LAND NORTHWEST OF SOUTHWATER

Proposed Worthing Road Access 5

Road Safety Audit – Stage 1

TBL19/616

DRAWING NO.	TITLE
UK0043490.9681-WSP-XX-XX-DR-TP-0109 - P03	General Arrangement B2237 Worthing Road/A24 Hop Oast Roundabout Sheet 01
UK0043490.9681-WSP-XX-XX-DR-TP-109 (2)	General Arrangement B2237 Worthing Road/A24 Hop Oast Roundabout Sheet 02

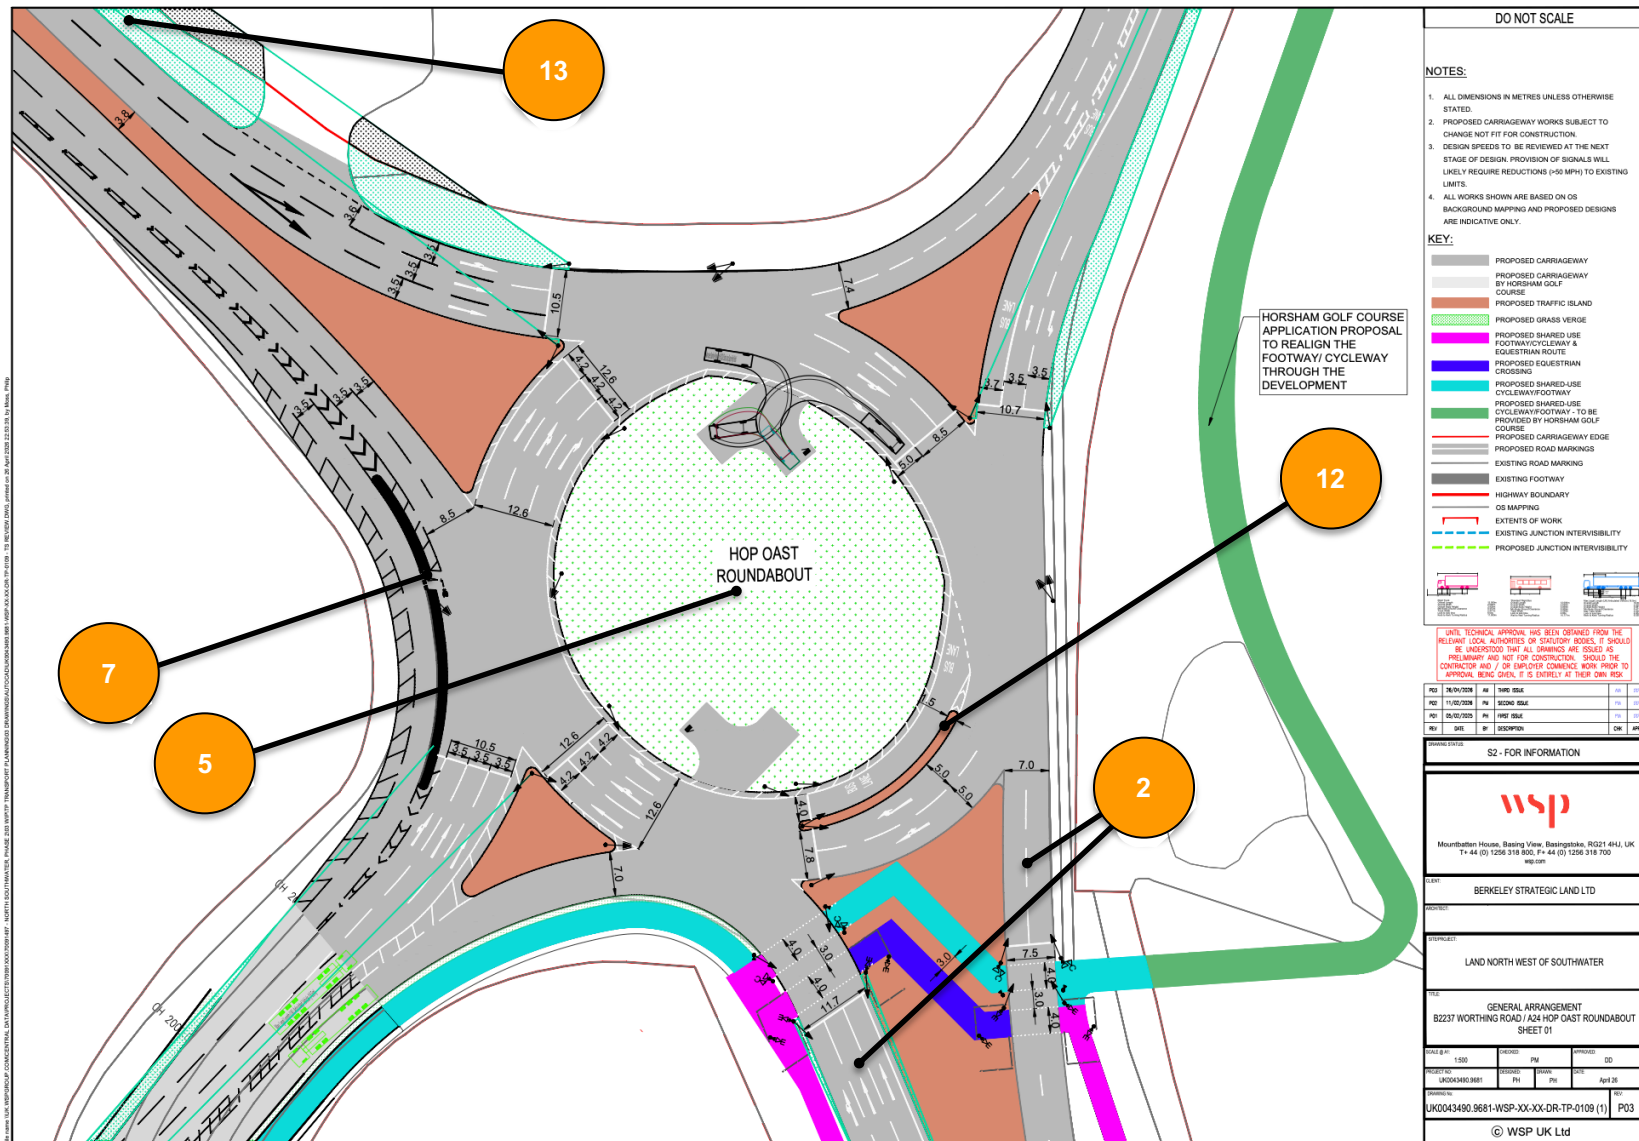
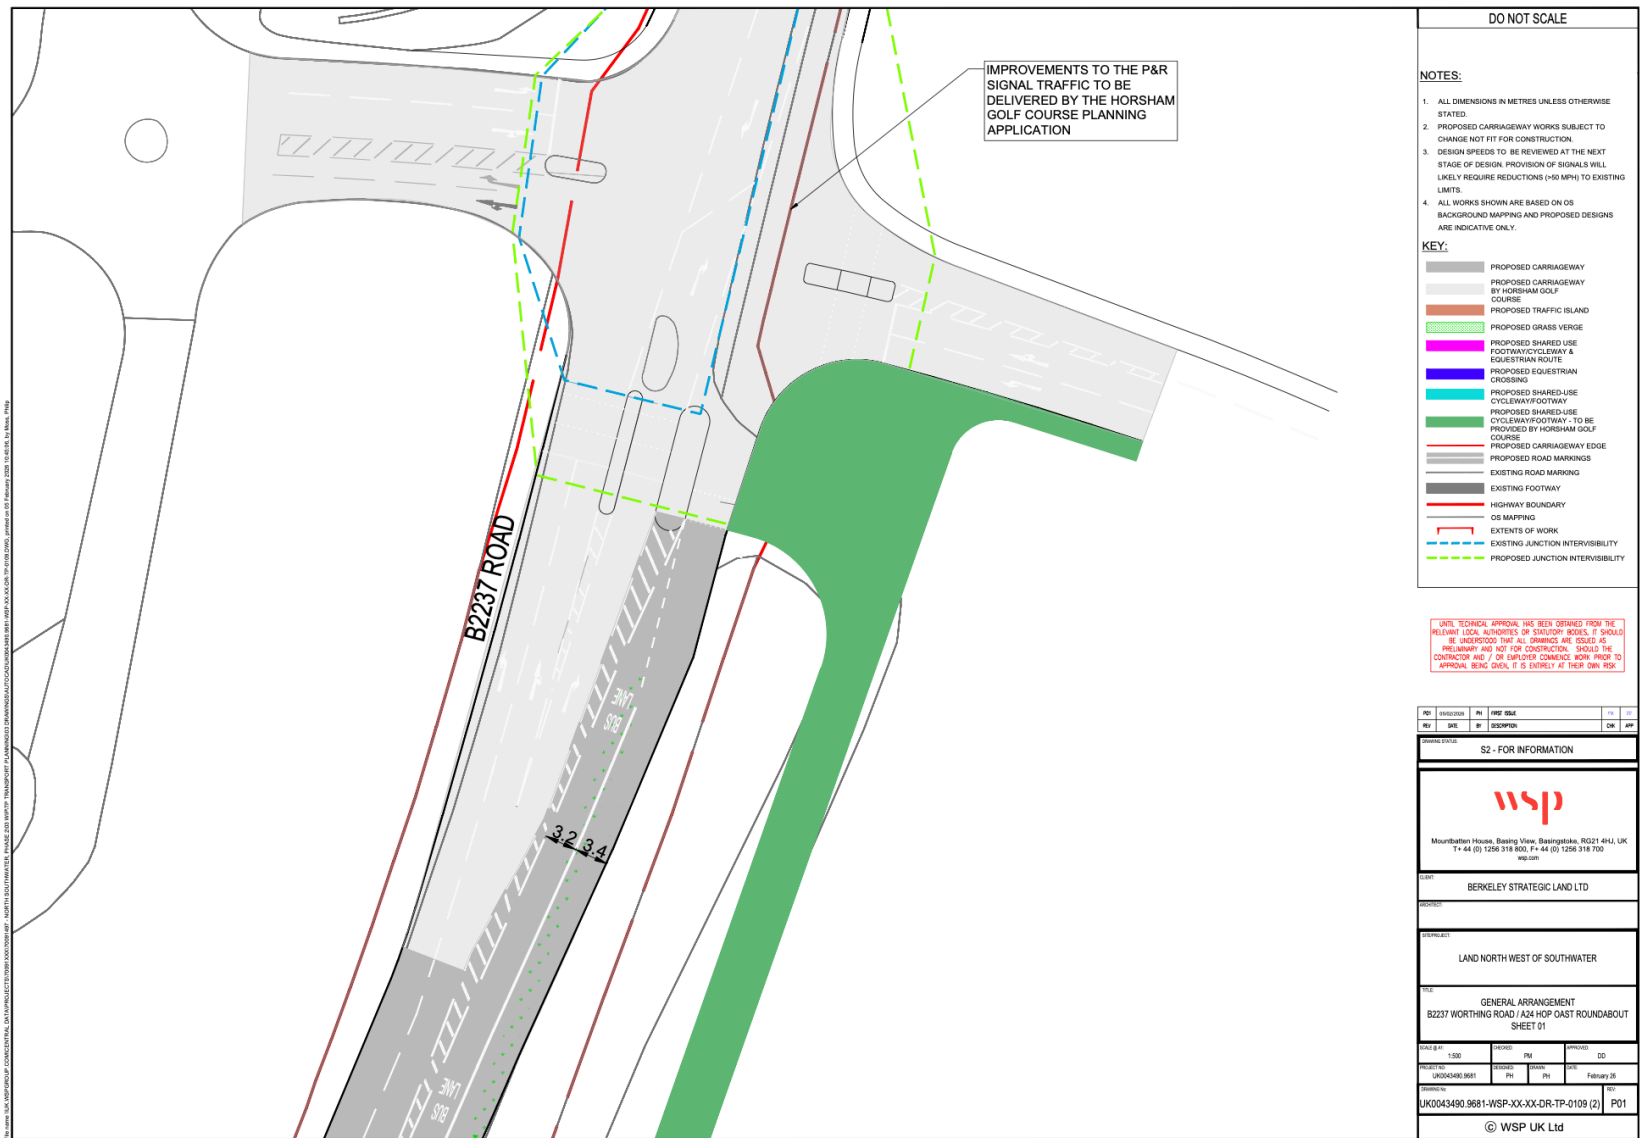
PROBLEM	1
Location	General, throughout the scheme extents
Summary	Insufficient drainage may increase the risk of flooding and single vehicle loss of control type collisions.
Drainage proposals have not been submitted at this stage of audit. The implementation of the proposals will result in a significant change to the existing kerb lines. Lack of surface water drainage may result in surface water ponding with the potential slide risk for vehicles during wet and subsequent cold/freezing weather conditions. This may increase the risk of single vehicle loss of control type collisions. In the vicinity of new crossing facilities this may result in an increased risk of slip/fall by pedestrians.	
RECOMMENDATION	
The Audit Team recommend that at the next stage of design, new drainage appropriate for the proposed highway works is incorporated into the scheme proposals.

PROBLEM	5
Location	Proposed roundabout junction
Summary	Insufficient carriageway width may increase the risk of side swipe type collisions.
The drawing provided at this stage of audit indicates that a three-lane entry is proposed for all the junction entries except the A24 (north). At this stage of audit, vehicle swept paths have not been provided. Without this information it is unclear whether three vehicles can safely enter the roundabout side by side. Insufficient carriageway widths may increase the risk of vehicle to vehicle side swipe type collisions.	
RECOMMENDATION	
The Audit Team recommend that lane/carriageway widths are sufficient to cater for the intended movements i.e. accommodate three vehicles entering the roundabout side by side. Furthermore, vehicle swept paths should be undertaken to ensure that all turning movements can be safely accommodated.

PROBLEM	6
Location	General, throughout the scheme extents.
Summary	Omission of appropriate corduroy tactile paving may increase risk of pedestrian to cyclist type collisions.
The scheme drawing indicates that shared and footway only links are proposed. The omission of the required corduroy paving and associated signing may result in pedestrians, particularly blind or visually impaired, not being aware of the presence of cyclists with an increased risk of collisions occurring between these user types.	
RECOMMENDATION	
The Audit Team recommend that the appropriate tactile paving and signing is incorporated into the scheme design.

PROBLEM	7
Location	Proposed cycle cut-through gap
Summary	Width of cut-through gap may not safely accommodate cyclists crossing the carriageway. Risk of vehicle to cyclist type collisions.
The drawing indicates that a cycle gap is proposed between the western and northern arms of the roundabout. Proposed widths are not indicated. A lack of sufficient width may leave cyclists vulnerable to circulatory traffic with an increased risk of vehicle to cyclist type collisions.	
RECOMMENDATION	
The Audit Team recommend that the proposed cycle gap can safely accommodate both pedestrians and cyclists.

PROBLEM	9
Location	General, throughout the scheme extents
Summary	Existing street furniture, signs and lighting columns may be vulnerable to vehicular strikes due to insufficient lateral clearance.
The scheme proposals indicate that significant kerb realignment is proposed to accommodate the roundabout proposals. At present there are a number of items of existing street furniture, signing and lighting columns, within the adjacent verge areas and traffic splitter islands. From the drawing provided for this audit it is unclear where these will end up being located. Inappropriately sited street furniture may be vulnerable to vehicular strikes due to insufficient lateral clearance. Further, street furniture remaining close to or within the proposed footway/shared/crossing facilities may create an obstruction for pedestrian/cyclists/equestrians resulting injury.	
RECOMMENDATION	
The Audit Team recommend that all street furniture is sited appropriately.

PROBLEM	11
Location	General, approaches to the roundabout
Summary	Insufficient guidance for drivers may increase risk of sudden braking, hesitation or lane changes resulting in rear end shunt and side swipe type collisions.
The introduction of additional lanes for all traffic and a bus lane will require information to be given to drivers to ensure they have sufficient time to enter the correct carriageway lane. A lack of guidance for drivers may result in sudden braking, hesitation or late lane changing with an increased risk of rear end shunt and side swipe type collisions.	
RECOMMENDATION	
The Audit Team recommend that appropriate and clear guidance is provided to drivers to ensure that correct lane choices can be made safely.

Summary	Risk of drivers striking the proposed bus lane traffic island may increase the risk of loss of control type collisions
The scheme proposals include the introduction of a bus lane within the roundabout circulatory. The drawings at this stage of audit do not show any means of highlighting this feature. A lack of clear guidance for drivers of this feature may increase the risk of vehicular strikes, particularly during the hours of darkness.	
RECOMMENDATION	
The Audit Team recommend that appropriate signing and demarcation of this feature is provided and that the feature should be visible to drivers in all lighting conditions.

PROBLEM	13
Location	A24 southbound approach verge
Summary	Lack of advance signing could increase risk of vehicle to vehicle side swipe and/or rear end shunt type collisions
The site visit has established that at the location identified there is an existing sign located within the verge area providing lane guidance to drivers for the current layout. It is important that any signing matches the proposed layout to ensure that drivers have sufficient time to enter the correct carriageway lane. Failure to provide adequate advance signing may increase the risk of sudden lane changing, hesitation or braking which may increase the risk of vehicle to vehicle side swipe and/or rear end shunt type collisions.	
RECOMMENDATION	
The Audit Team recommend that appropriate signing that reflects the proposed layout is incorporated into the design to warn drivers of the correct lane approach.
